ADDENDUM #2

Renovations to:
M.C.S. Noble Middle School
6520 Market Street
Wilmington NC 28405

Project ID: 900-9008

C2.01

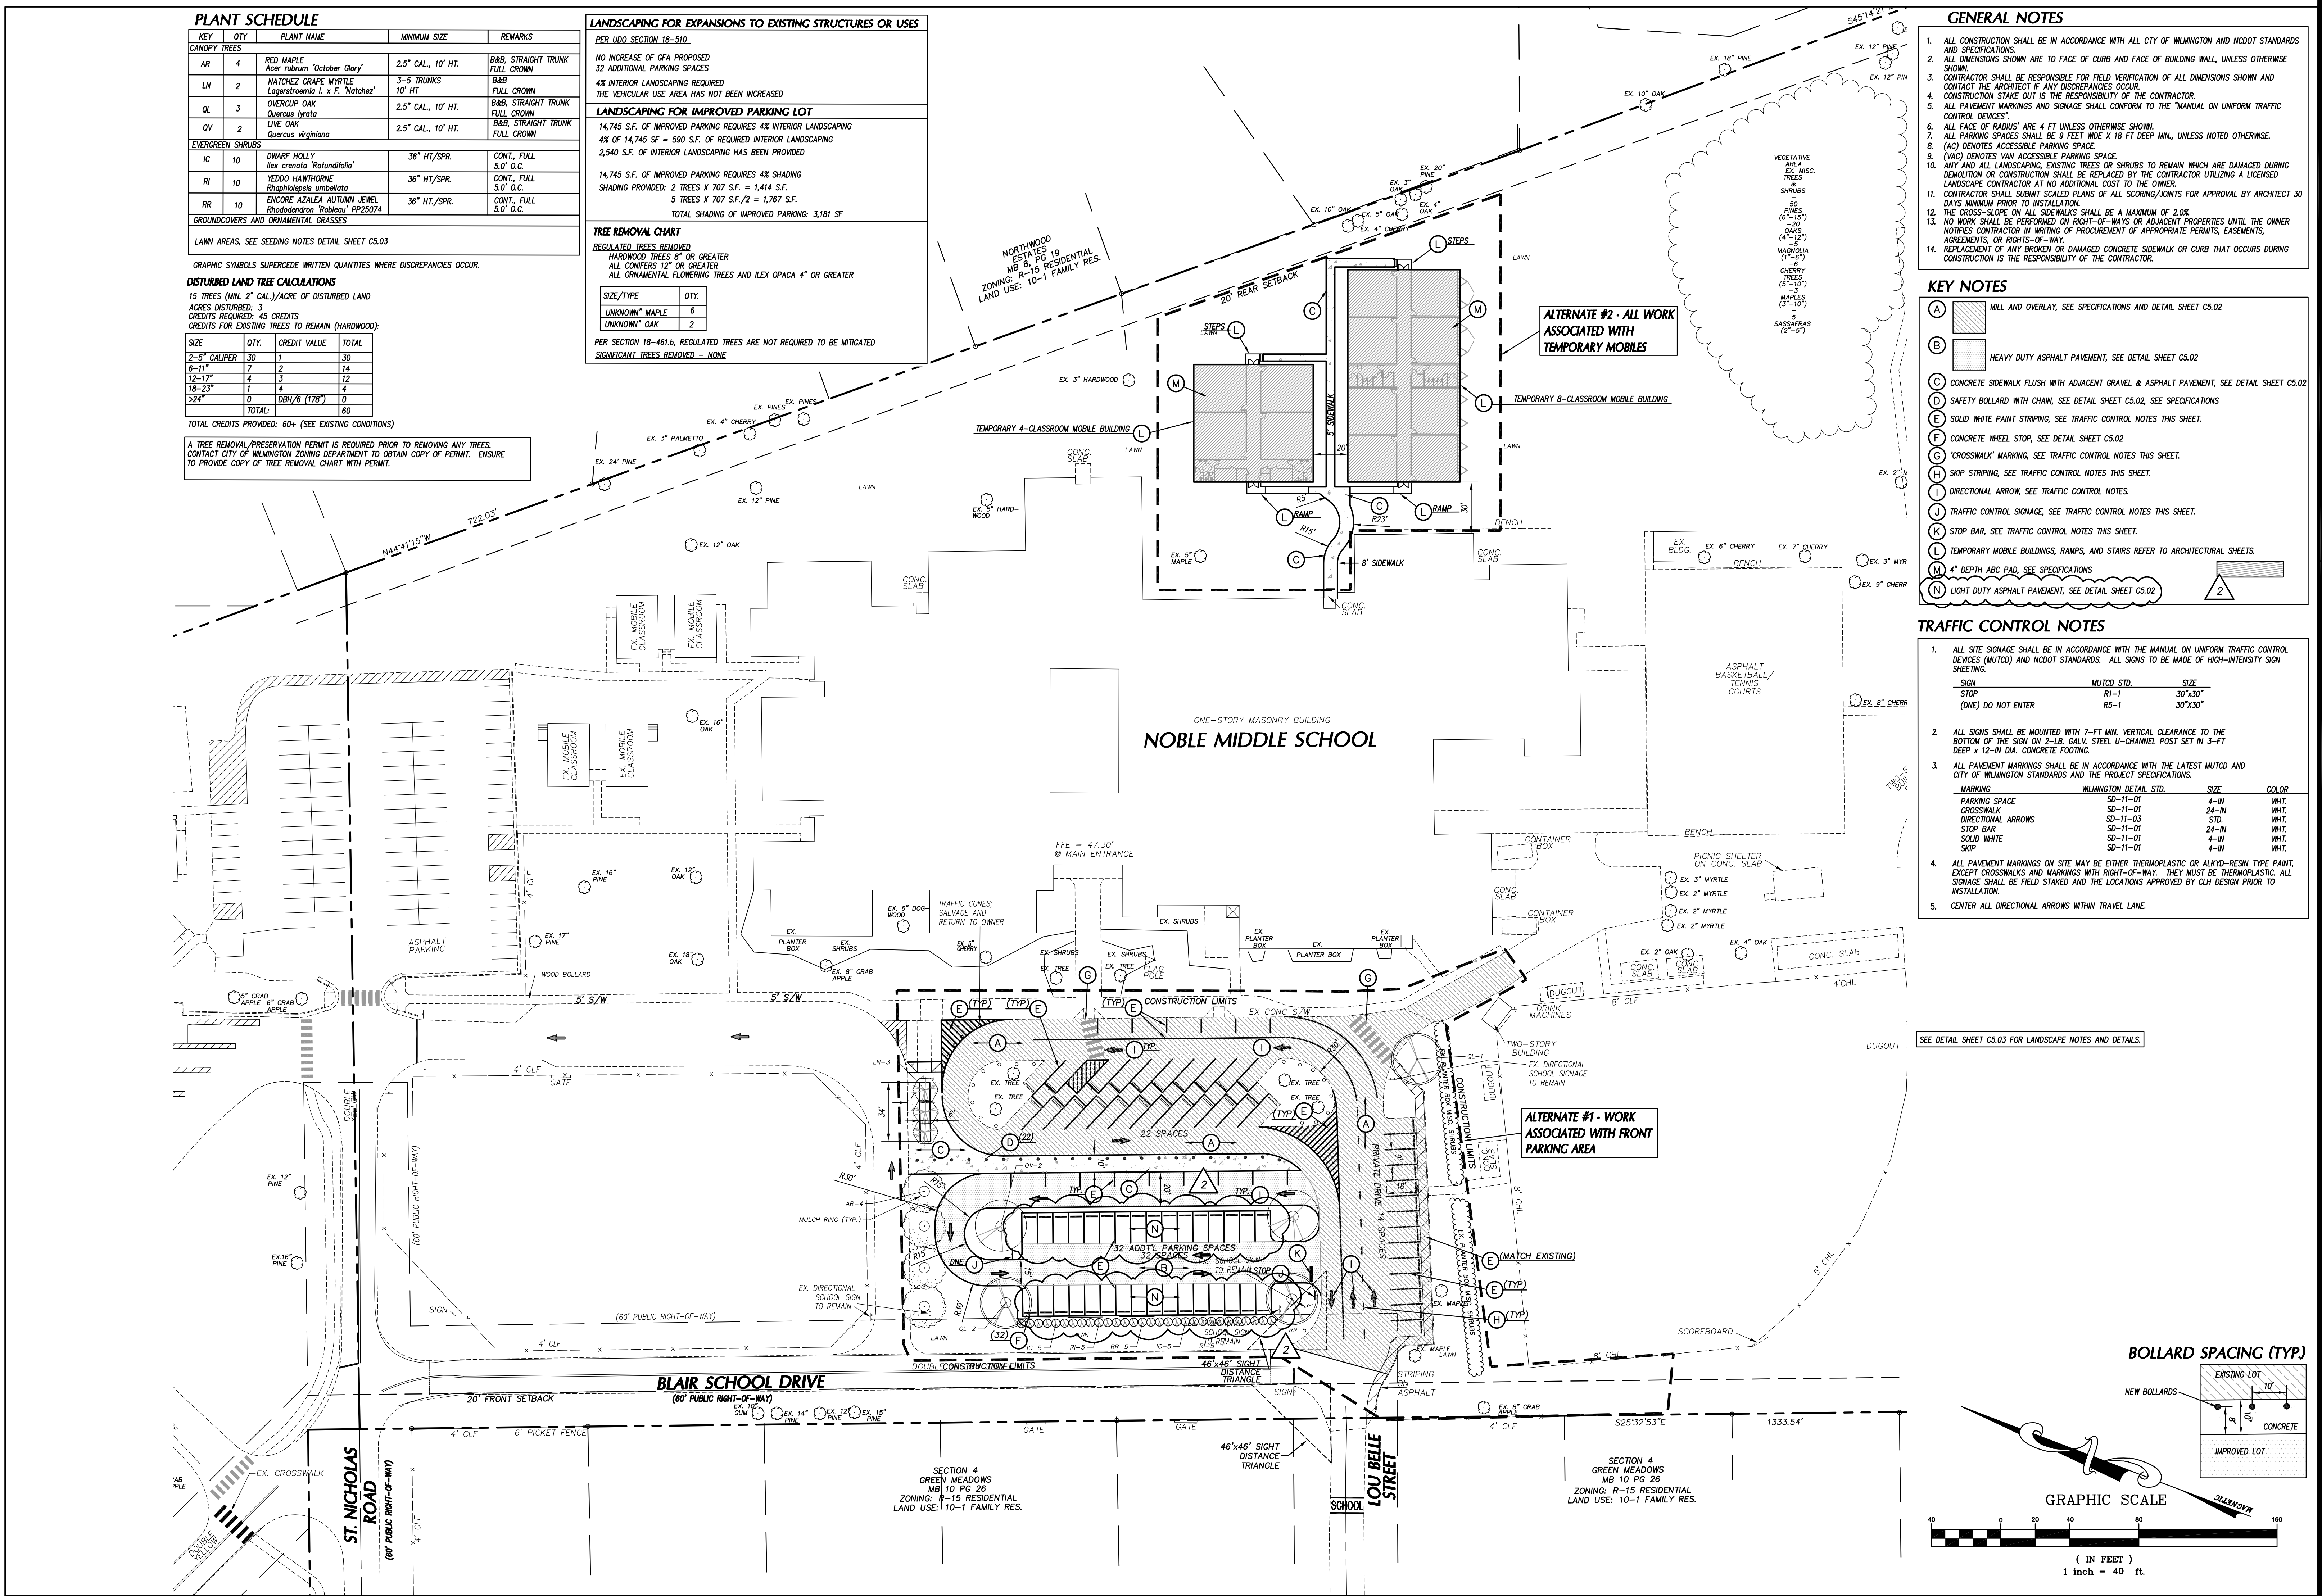
Item 4 **Drawings, C2.01 Staking and Planting Plan**
 Parking area has been revised to show light duty asphalt paving.

Revised drawing C2.01 is included as **attachment #1**.

ASPHALT PAVEMENT N.T.S.

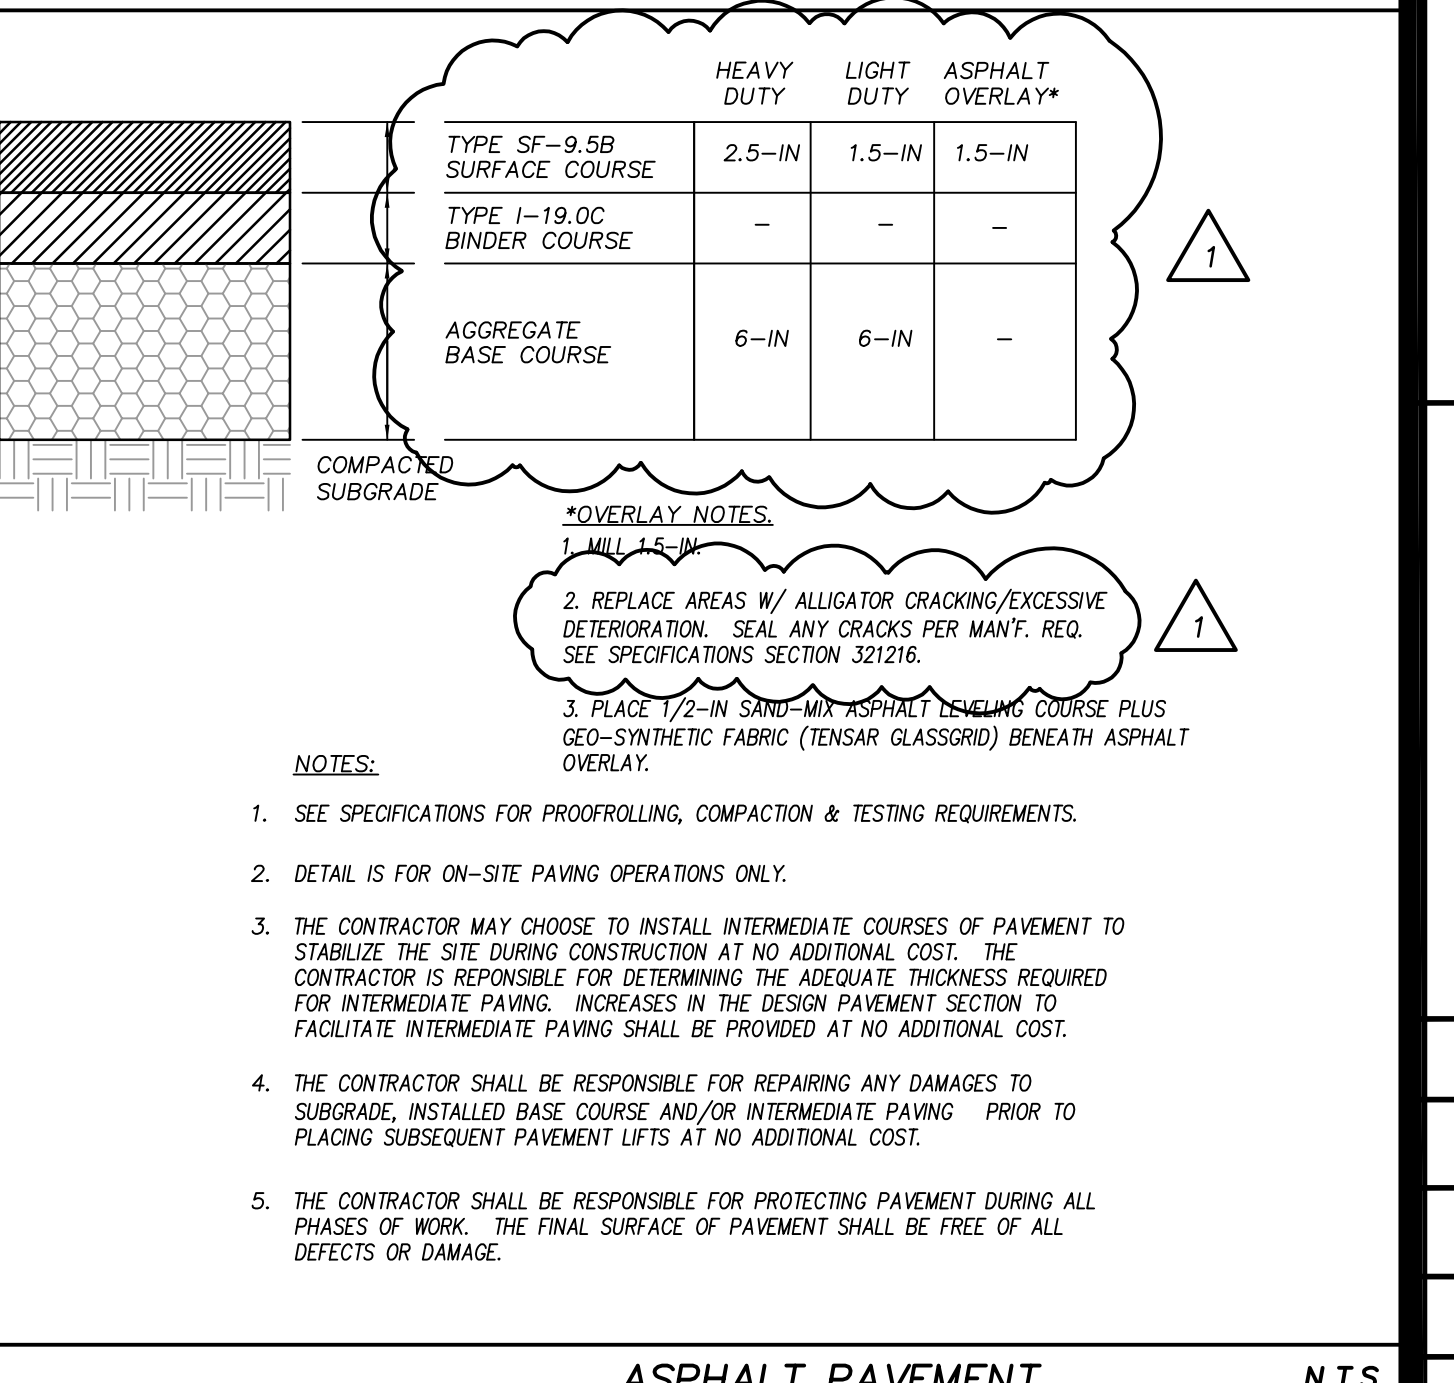
Item 5 **Drawings, C5.02 Site Details**
 Asphalt Pavement Detail and Overlay Notes have been revised.

Revised drawing C5.02 is included as **attachment #2**.
